STATE OF TEXAS
TEXAS DEPARTMENT OF TRANSPORTATION
PLANS OF PROPOSED
STATE HIGHWAY IMPROVEMENT

CSJ: 0074-06-199
PROJECT CC 74-6-199
ALAMEDA STREET BRIDGE
NUECES COUNTY
ROADWAY = 360 ft. = 0.068 miles BRIDGES = 0.0 ft. = 0.0 miles
TOTAL LENGTH OF PROJECT: 360 ft = 0.068 miles
LIMITS: ALAMEDA BRIDGE BETWEEN MARTIN LUTHER KING & ANTELOPE
CONSTRUCTION OF: PROVIDING PEDESTRIAN ENHANCEMENT ON ALAMEDA ST BRIDGE
CONSISTING OF: PEDESTRIAN WALKWAYS, PEDESTRIAN LIGHTING, LANDSCAPE, IRRIGATION

CHANGE ORDER •1:

CHANGE ORDER
SUMMARY

Title: Bridge Pipe Arches

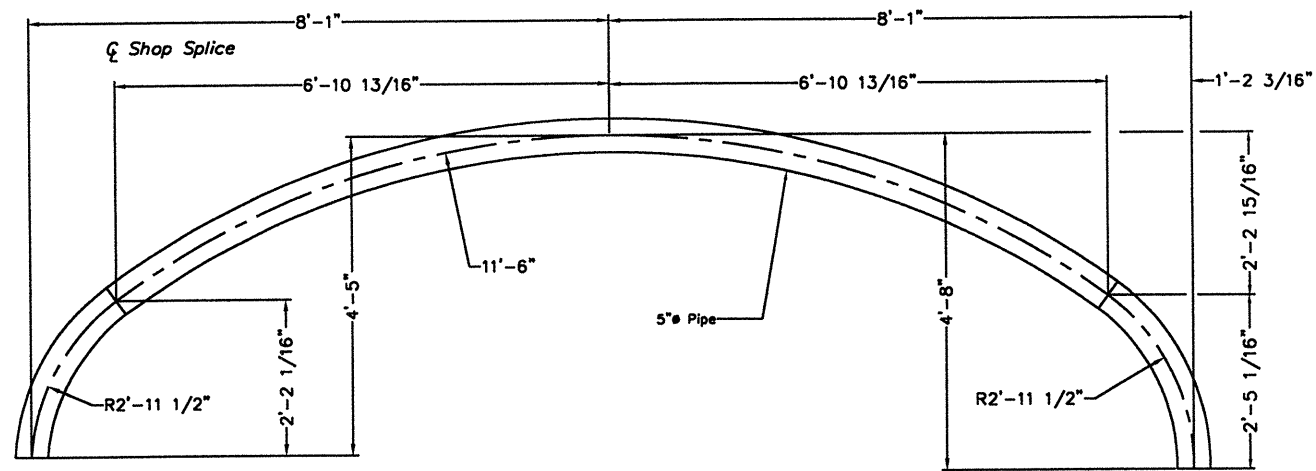
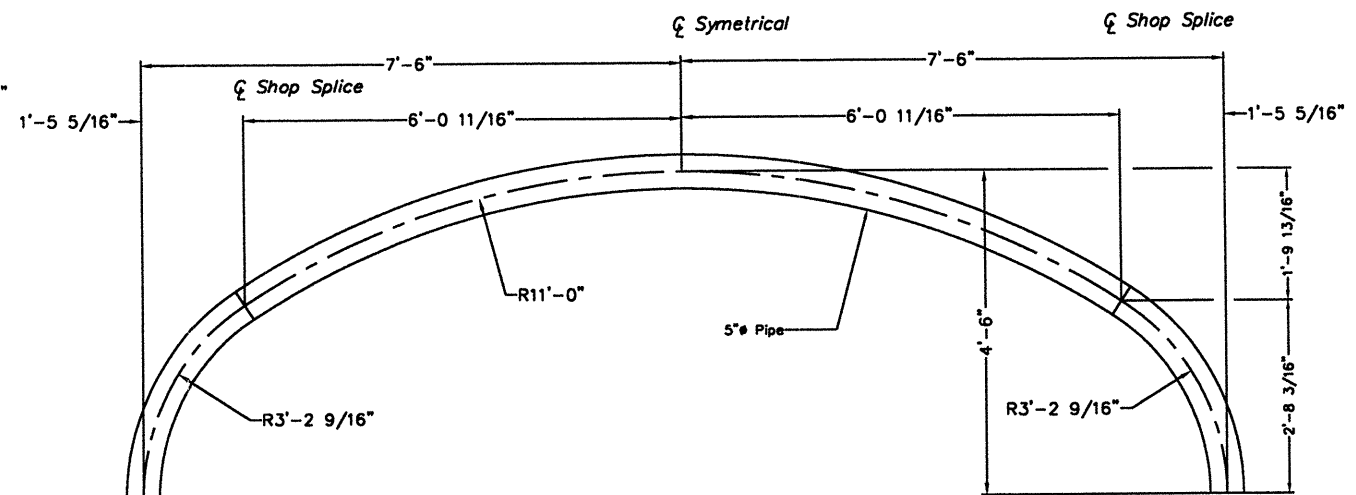
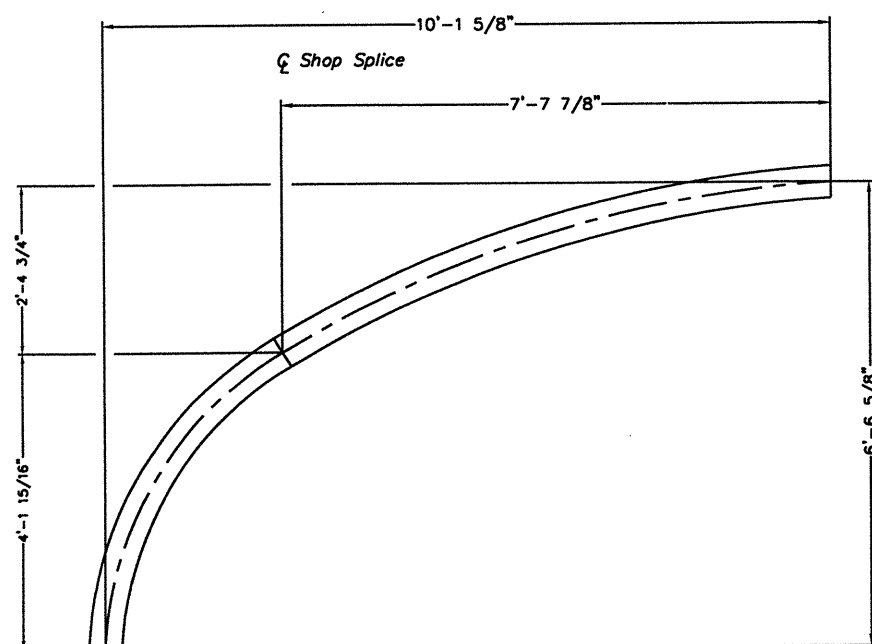
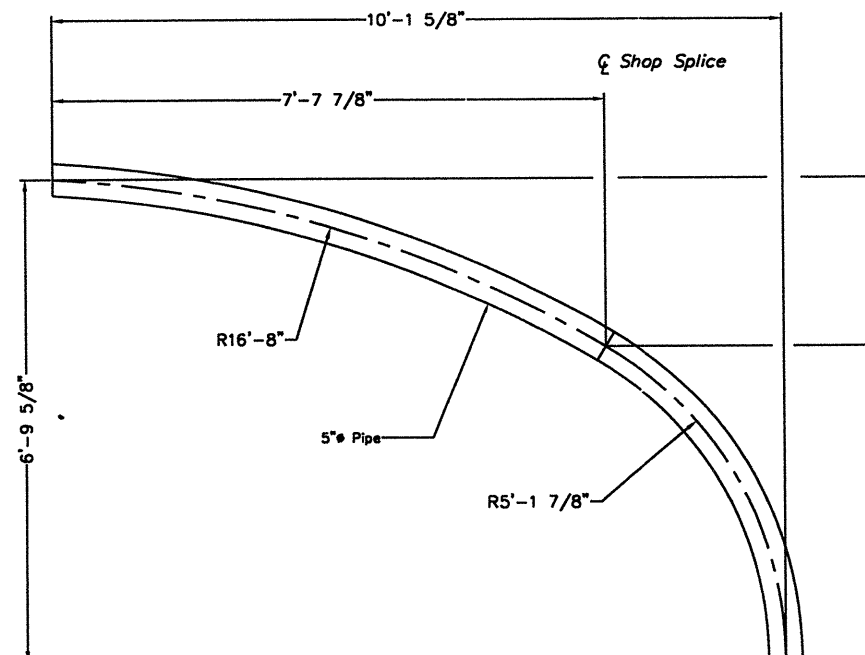
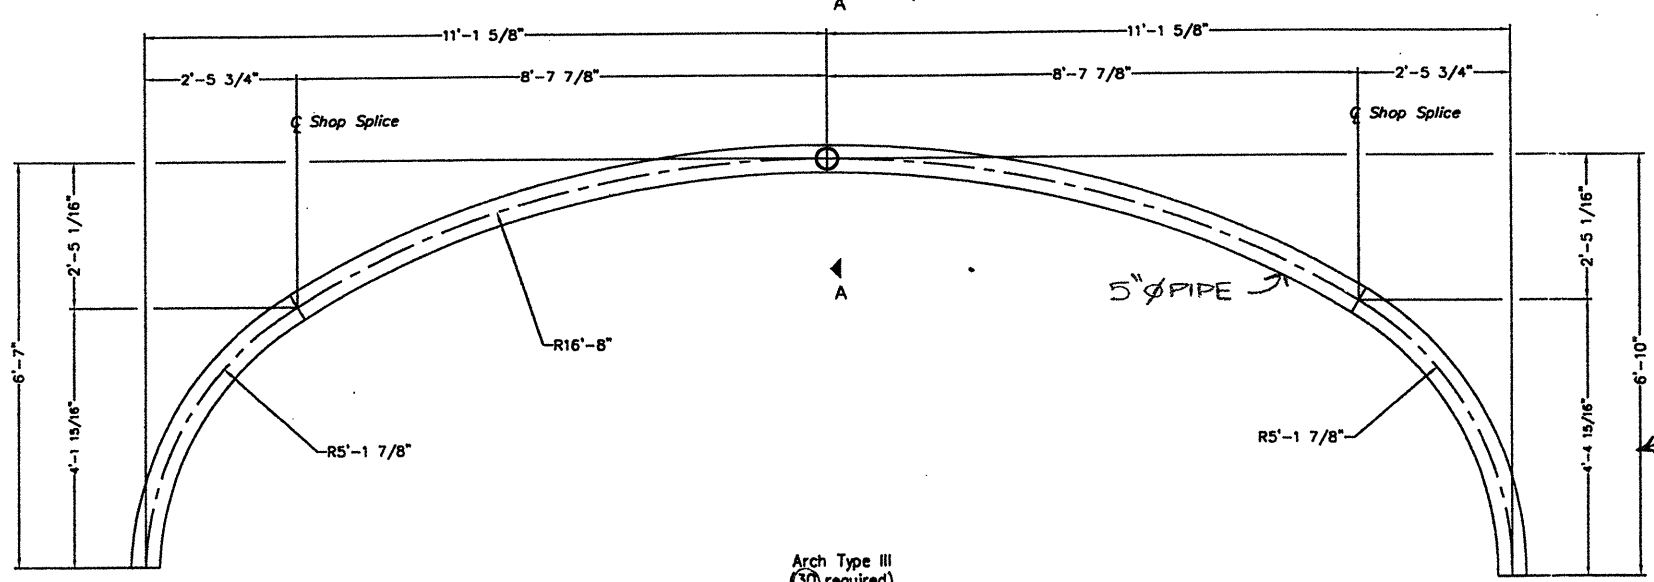
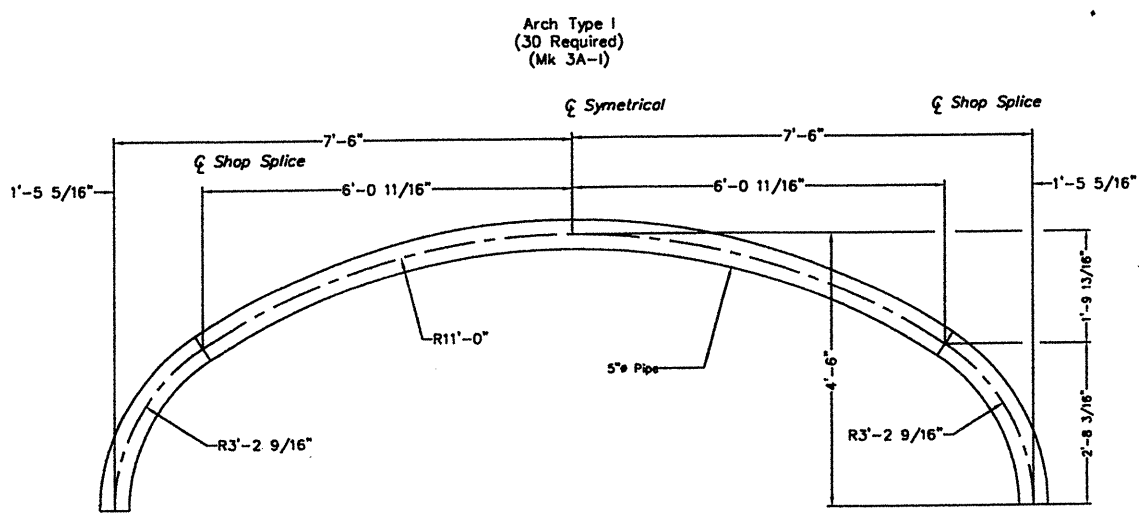
☐ APPROVED
☒ APPROVED AS NOTED
☒ RE-SUBMIT

REVIEW IS ONLY FOR CONFORMANCE WITH THE DESIGN
CONCEPT OF THE PROJECT. CONTRACTOR IS RESPONSIBLE
FOR DIMENSIONS, QUANTITIES AND PERFORMANCE IN
ACCORDANCE WITH CONTRACT DOCUMENTS.
DATE: 11-17-04 BY: [Signature]
MAVERICK ENGINEERING, INC.
